MEMORANDUM

SUBJECT: MS-20-002 – Dwire Storage Yard Filing No. 1
First Submittal

Dwire Storage Yard
Filing No. 1
Transportation Memorandum
(LSC #194930)
January 30, 2020

LSC Responses to TIS Redline Comments

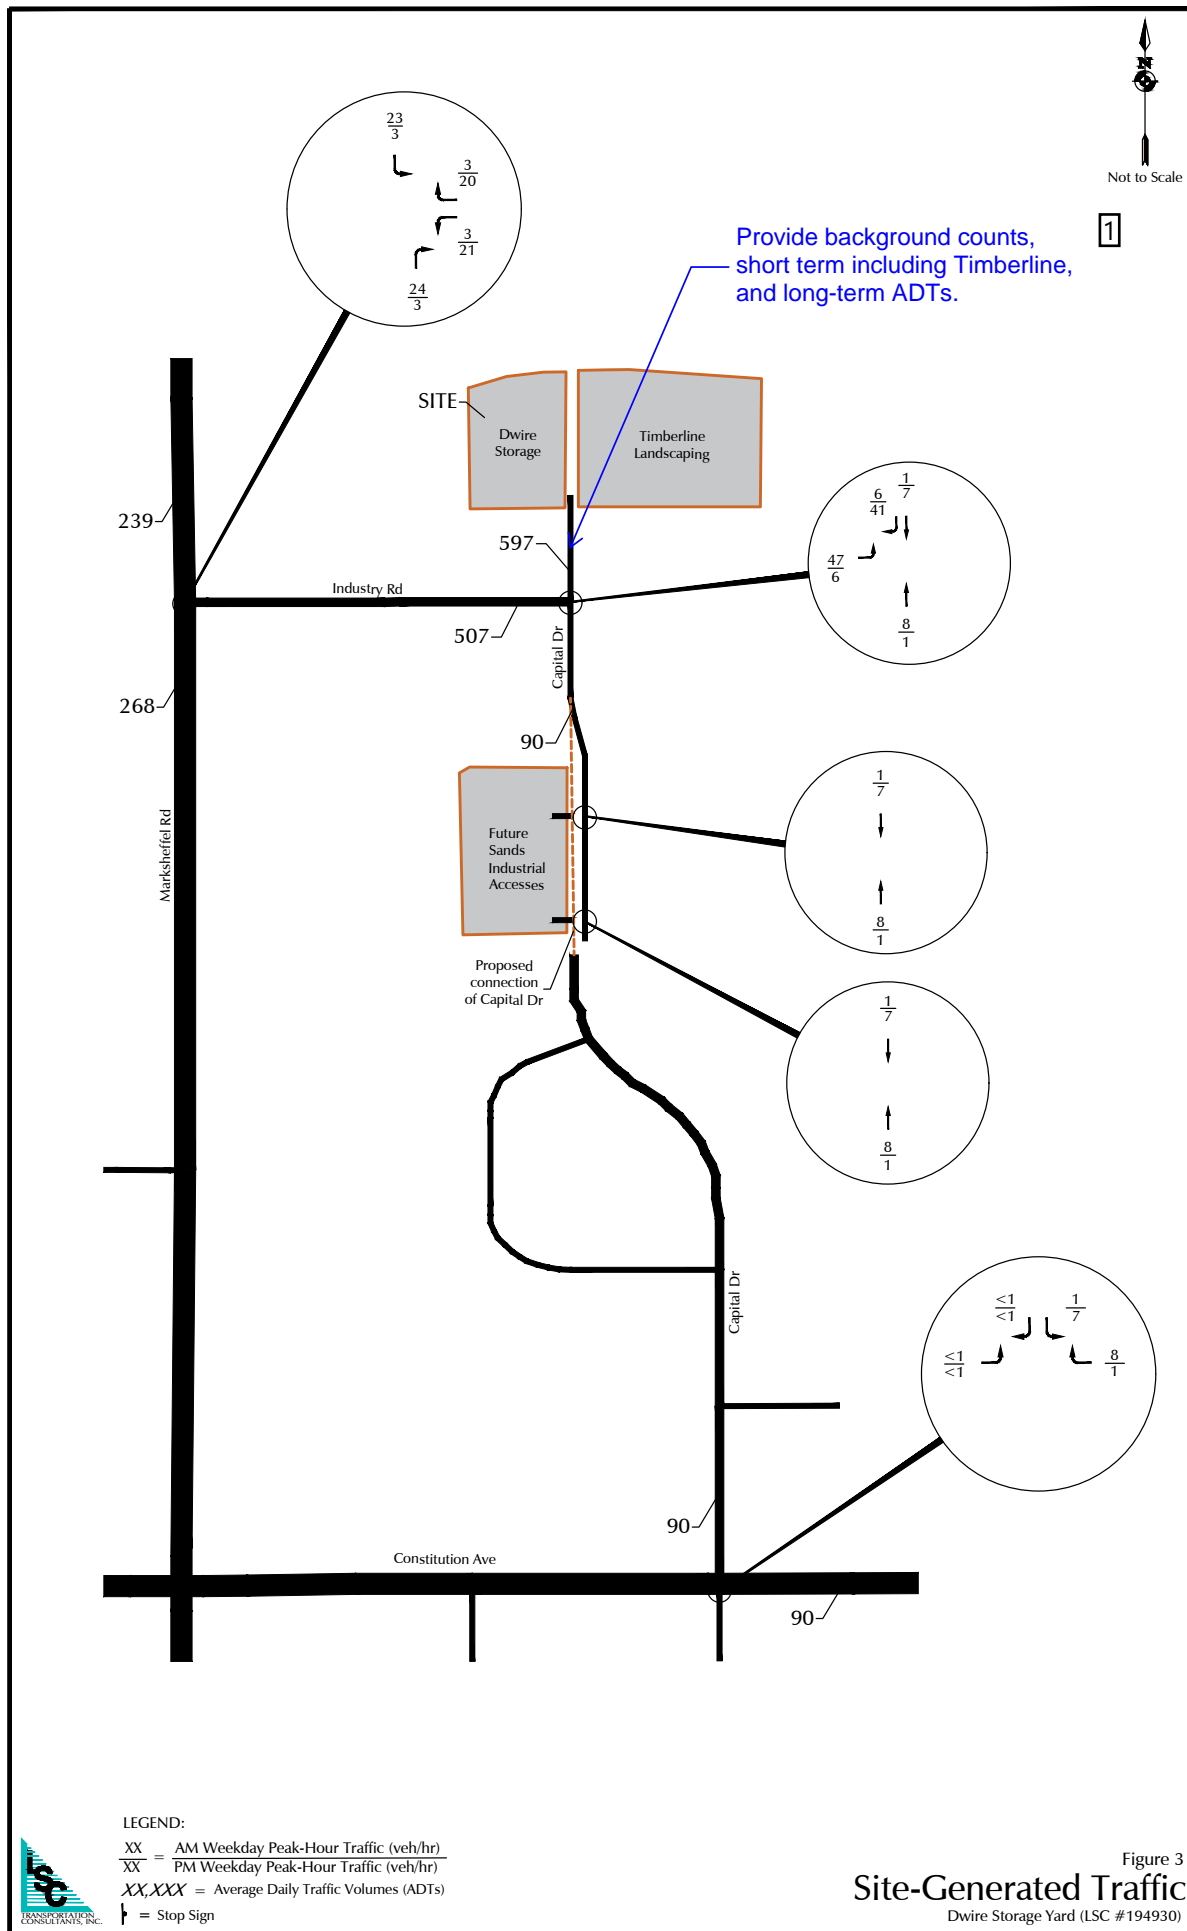
Provide Timberline calculations (not approved yet).

Provide background counts, short term including Timberline, and long-term ADTs.

LSC Response: The updated report explains that Timberline Landscaping (including existing buildings/business operations) trip generation is included in the existing traffic volumes. Existing traffic volumes for the NORTH LEG of the intersection of Industry Drive/Capital Drive include Timberline Landscaping traffic along with traffic from other existing businesses with access to Capital Drive north of Industry Drive.

LSC Response: Figure 5 of the updated report presents background traffic for the Sands Industrial as well as a background component for future additional development within this overall business park area.
